IEEE 802.16 Broadband Wireless Access Working Group http://ieee802.org/16
Title	Comments on Frame Structure for multi-hop relay
Date Submitted	2007-1-18
Source(s)	Changyoon Oh, Youngbin Chang, Mihyun Lee, HyoungKyu Lim, Jaeweon Cho, Panyuh JooVoice: +82-31-279-7529 Fax: +82-31-279-5130 mail to: changyoon.oh@samsung.comSamsung Electronics416, Maetan-3dong, Youngtong-gu, Suwon-si, Gyeonggi-do, Korea
	Rakesh Taori Samsung Advanced Institute of Technology
	Jerry Sydir Jerry.sydir@intel.com Intel corperation
Re:	Response to call for technical contributions on 80216j-06_027, "Call for Technical Proposals regarding IEEE Project P802.16j", Sep.15,2006
Abstract	This contribution proposes the detailed frame structures for the minimum configuration of frame structure and extends this to support multi-hop relay.
Purpose	Propose the text regarding frame structure design for multi-hop relay
Notice	This document has been prepared to assist IEEE 802.16. It is offered as a basis for discussion and is not binding on the contributing individual(s) or organization(s). The material in this document is subject to change in form and content after further study. The contributor(s) reserve(s) the right to

Figure 2. Example of minimum configuration for an in-band non-transparent relay frame structure (Suggested as a replacement to Figure xyz in [1]).

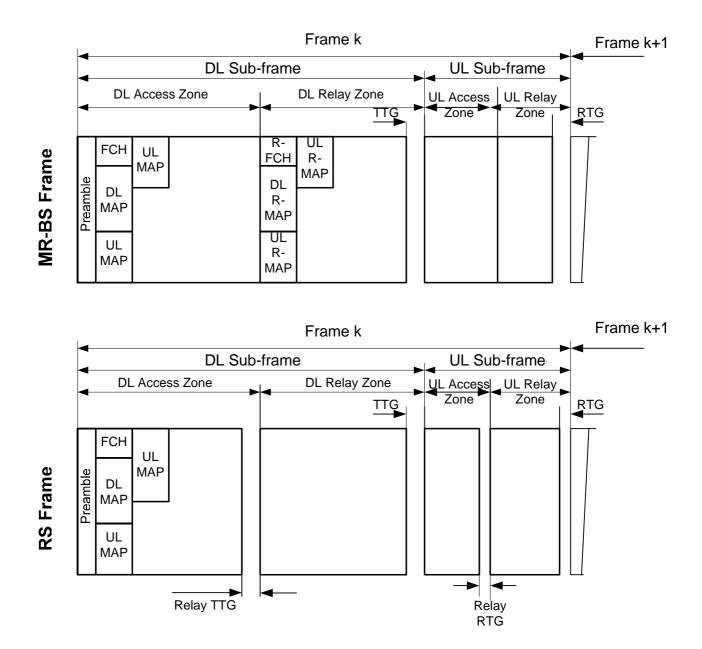
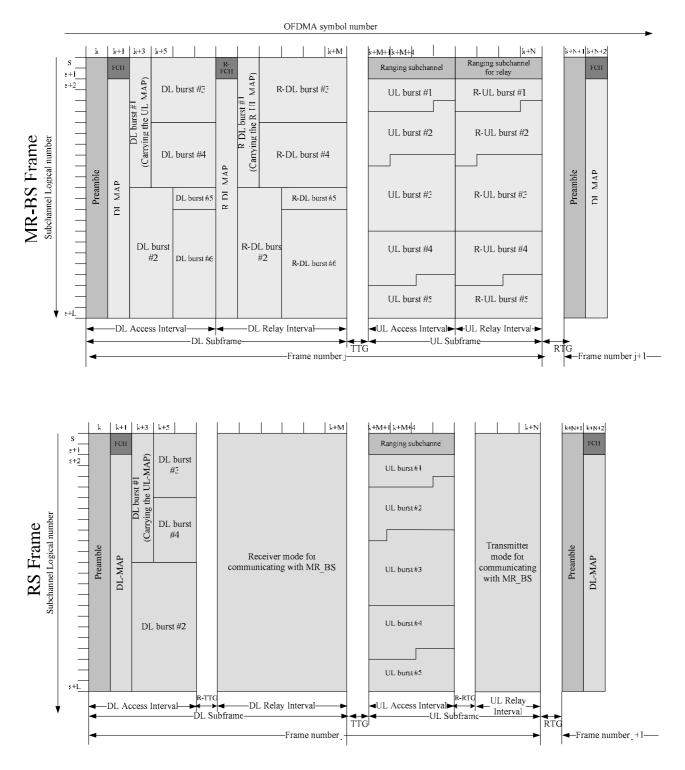
Figure 1 shows the minimum configuration of frame structure as agreed in the last meeting, i.e., a frame structure for two-hop relay. In this contribution Figure 2 is proposed with an aim to align Figure 1 such that it provides a similar level of detail as Figure 218 in the current specification .. In addition, it is argued that the term 'zone' used in the minimum configuration of frame structure may cause confusion when used together with the already existing terminology 'zone' as used in Figure 219, for instance. So, it is proposed that the term 'zone' as implied in [1] be replaced by the term 'interval' to avoid confusion.

Figure 3. Relay frame with multiple intervals

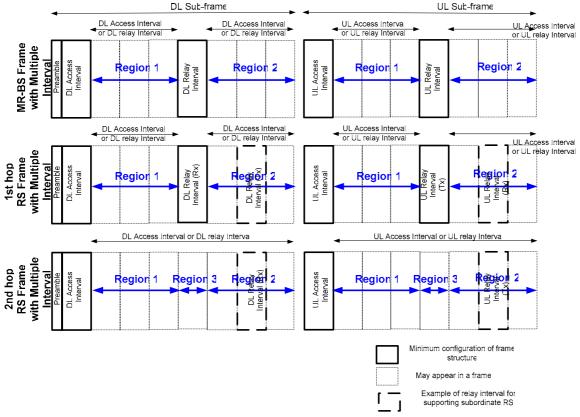
More importantly, to support multi-hop relay, the agreed minimum configuration of frame structure needs to be extended. Just as Figure 219 in the current specification [2] generalizes Figure 218, Figure 3 is provided as a generalization of Figure 2, to accommodate various frame configurations for supporting the multi-hop topology. According to the generalization illustrated in Figure 3, additional intervals to allow multi-hop capability may appear in a frame based on the minimum configuration of frame structure.

To be more specific, MR-BS frame and RS frame may have additional DL/UL access interval after the DL/UL relay interval to support its MSs. Alternatively, an RS frame may have additional DL/UL relay interval either before the DL/UL relay interval or after the DL/UL relay interval to support its subordinate RS. However, the number of additional interval may need to be limited for technical feasibility.

Note that the additional access intervals shall not include FCH and DL-MAP, while the additional relay interval may include R-FCH and R-DL-MAP.

Figure yyy Example of minimum configuration for an in-band non-transparent relay frame structure

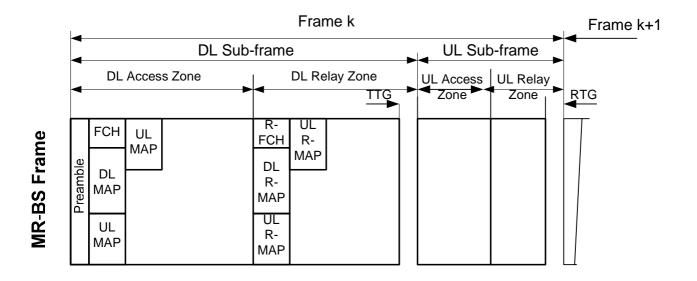
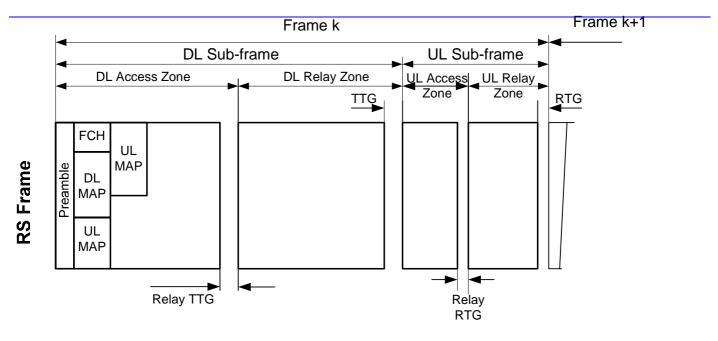
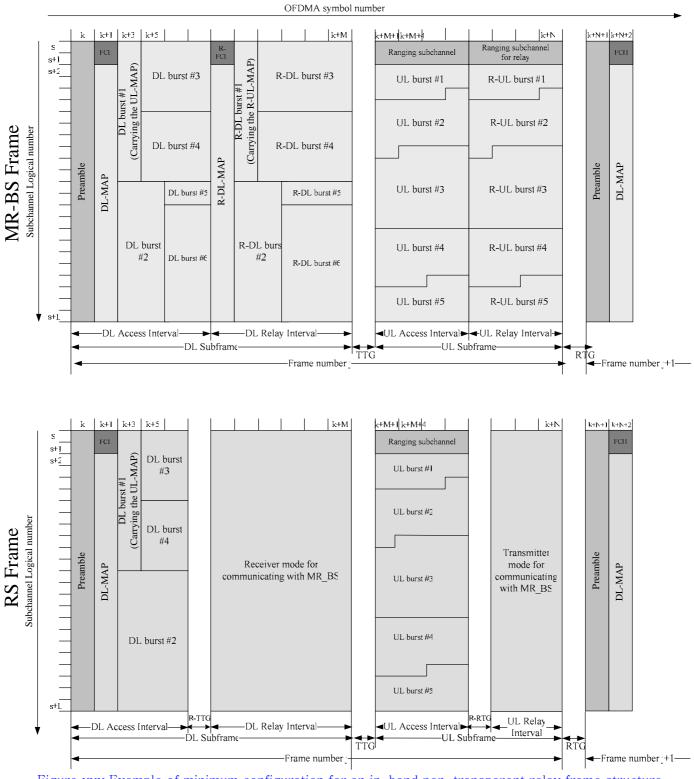
[Remedy 2: Replace Figure] [Replace Figure xxx with Figure yyy as follows:]

Figure yyy depicts the BS frame and the RS frame with multiple intervals.
